From: Larry Bastian <larry@terradynconsultants.com>
Sent: Monday, December 17, 2018 2:05 PM
To: Amanda L. Lessard
Cc: Jim Cummings (jimcummings111@gmail.com); Jeff Amos
Subject: Cook Road Retirement Community - Response to Review Comments
Attachments: 18218 Cook Rd Retirement Community Rev Figure 2 to Show Nitrate Plume.pdf; Response to J Earle Comments.pdf; USGS Watersheds_Cook Rd.pdf

TERRADYN RESPONSE TO COMMENTS NOTED IN BOLD ITALICS

From: Jonathan R. Earle
Sent: Friday, November 30, 2018 3:09 PM
To: 'Jeff Amos, P.E. '; Amanda L. Lessard
Subject: 18-31 Cook Road Retirement Community - Preliminary Plan Review Comments

PROJECT: COOK ROAD RETIREMENT COMMUNITY 306 GRAY ROAD - WINDHAM, ME	CLIENT: JIM CUMMINGS	TITLE: NITRATE-NITROGEN ASSESSMENT SITE PLAN	
		SCALE: 1" = 80'	DRAWN BY: KRF
DATE: DECEMBER 14, 2018		APPR BY: SBM	
173 PLEASANT STREET ROCKLAND, ME 04841 Tel: (207) 318-1161		SUMMIT GEOENGINEERING SERVICES	
145 LEBRON ST. - SUITE 101 LEWISTON, ME 04240 Tel: (207) 516-3313		PROJ.#: 18218	
FIGURE: 2

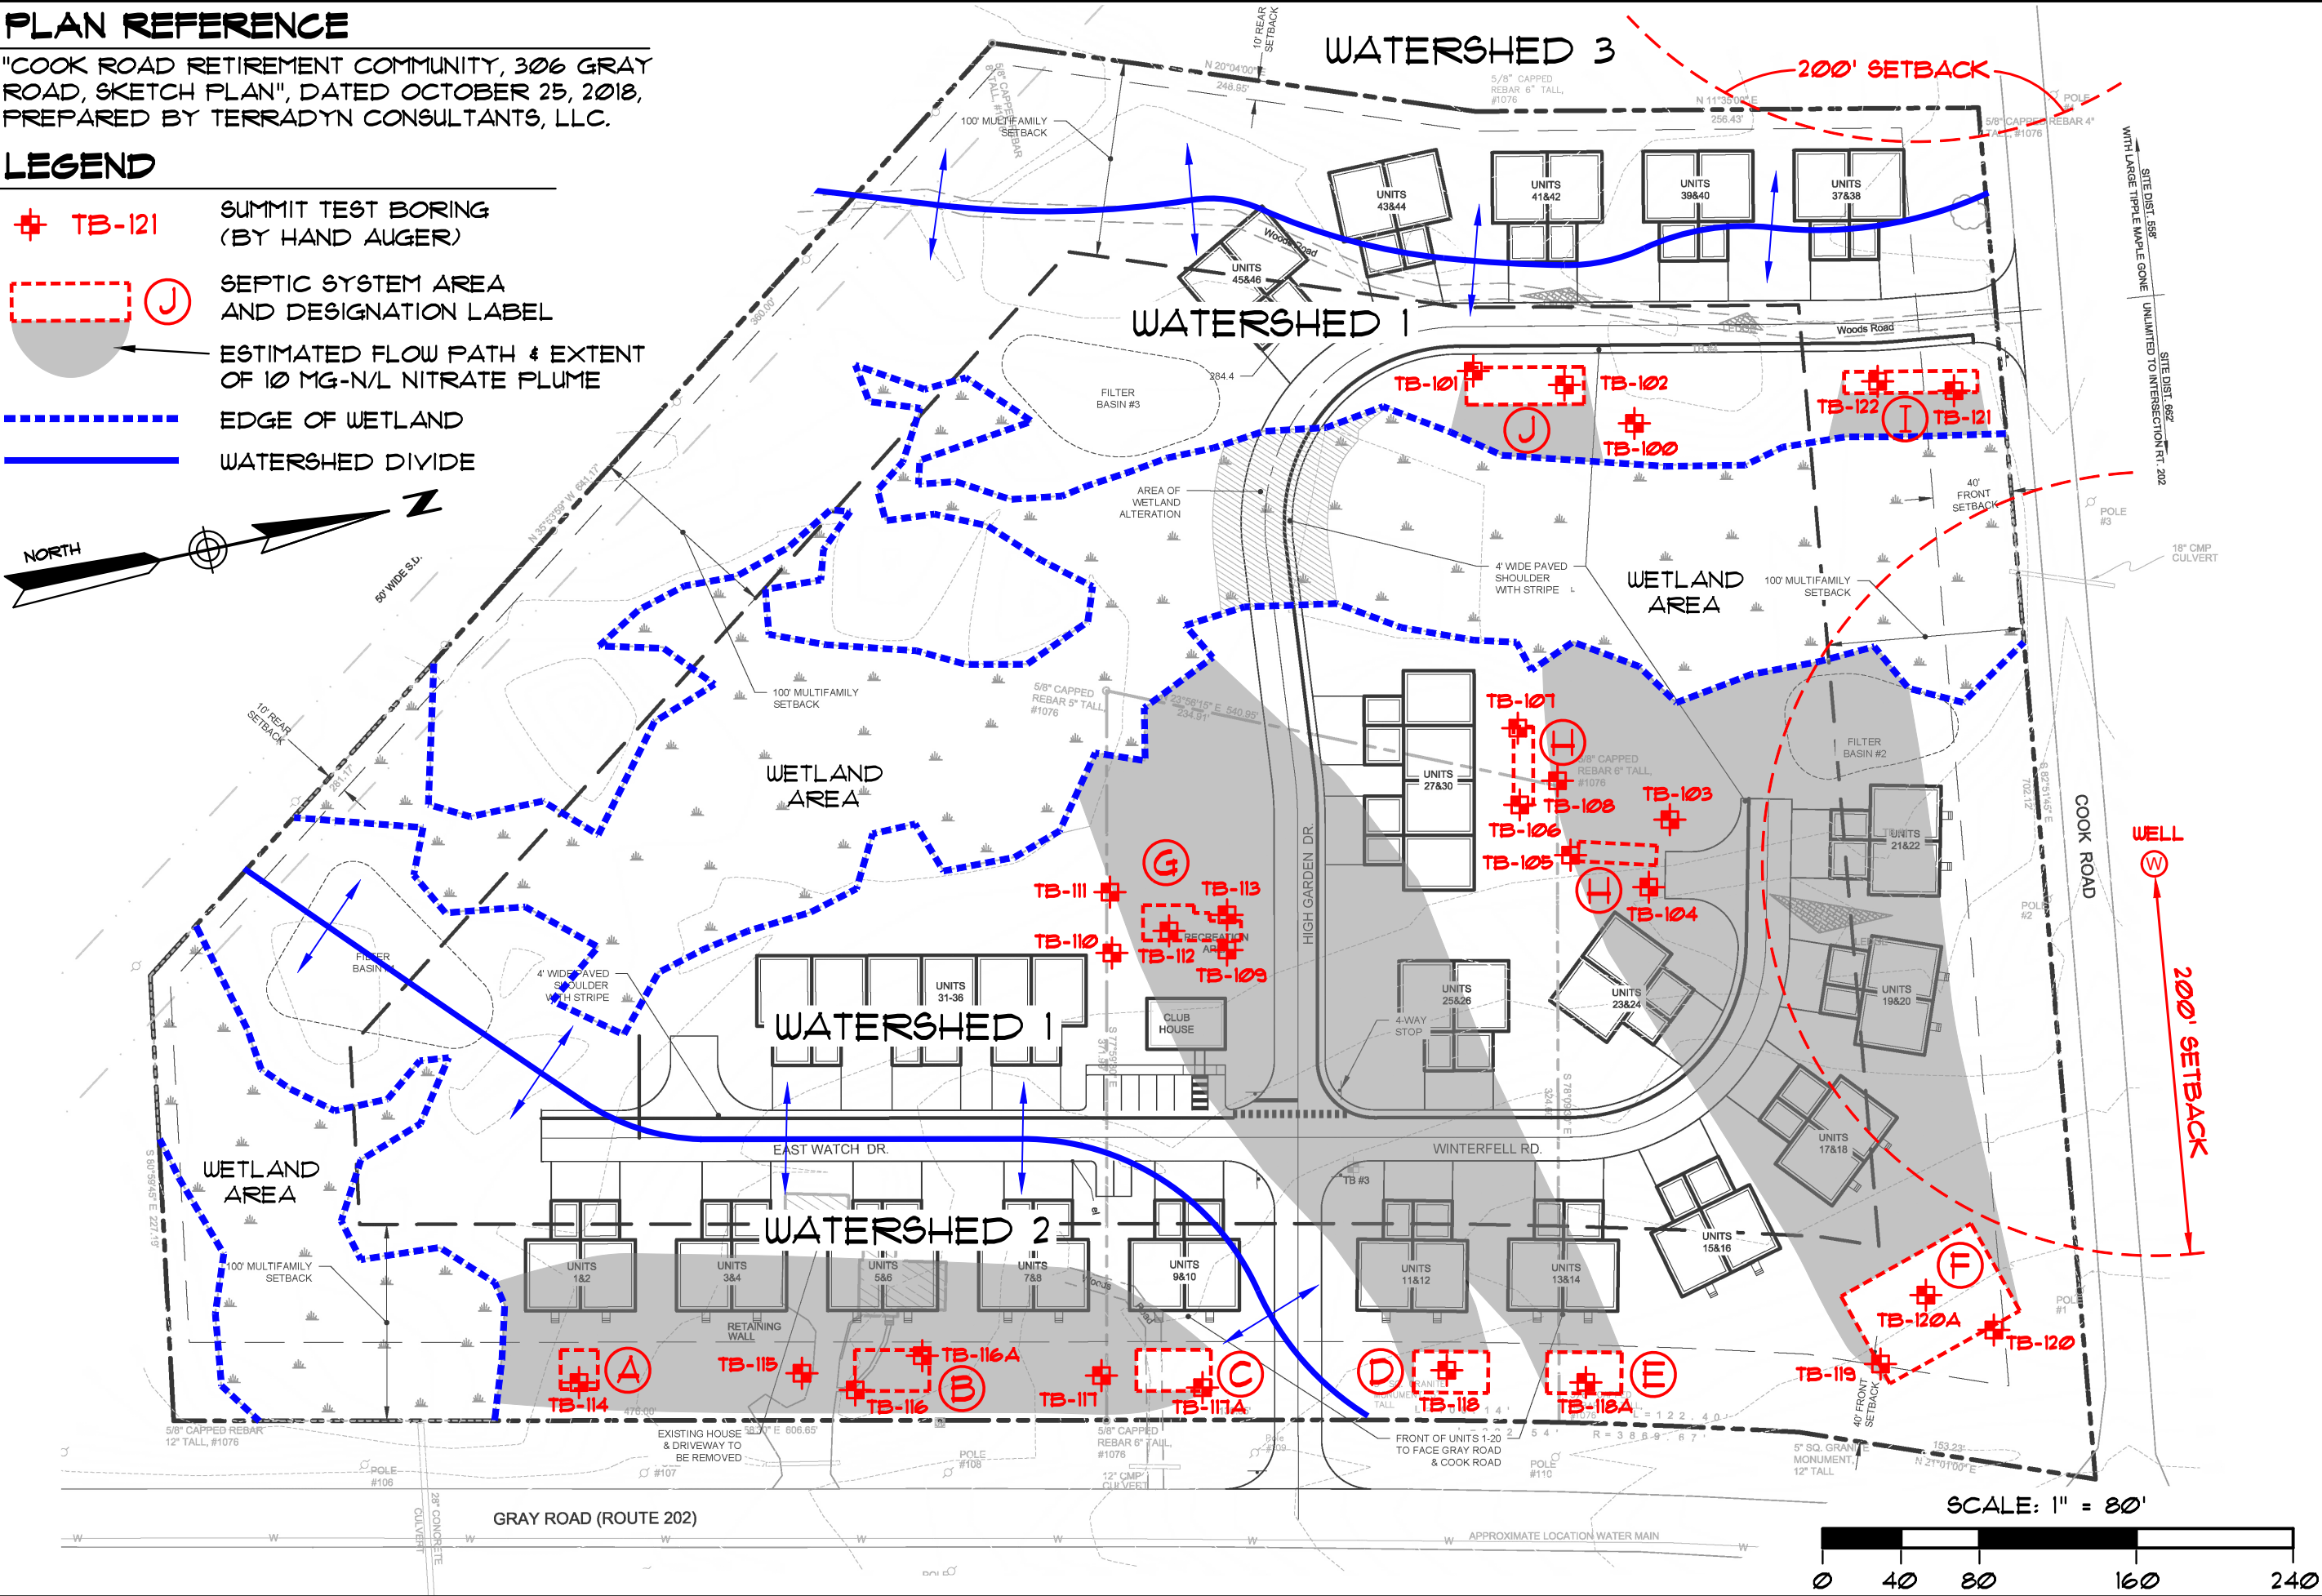
4. Will a plan be provided showing the nitrate plumes at each disposal field location. A statement from Steve Marcotte was provided which indicates that the nitrate discharge will be less than 10 mg/L at the property line, but a nitrate plume plan would be helpful in support of this criteria.

5. A nitrate plume plan is enclosed.
6. Portland Water District reviewed the plans and provided comments, which have been incorporated on the Utility Plan. We are forwarding the revised plans to PWD for their review in providing the ability to serve letter.

Submitted 12/17/2018
